BY	Submitted August 11, 2025
REVISION	Engineering Review Notes August 26, 2025
DATE

CONCEPTUAL UTILITY PLAN

THE VILLAGES AT ROSE HILL
1433 E COLLEGE ST
BROKEN ARROW, OK 74012

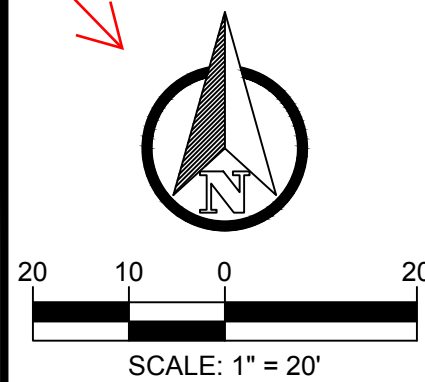
For clarity, emphasis the utility lines on the utility plan.

Show the water and sewer service lines to all the buildings

Do not connect sanitary sewer service lines directly into manholes.

If any of the proposed lines and fire hydrants that are "by others" are needed for this development, those will need their engineering plans completed and bonded before the site plan can be approved.

Show the water and sanitary sewer extensions shown on the AAB plans. And include any easements proposed on the AAB plans.

North Arrow points East
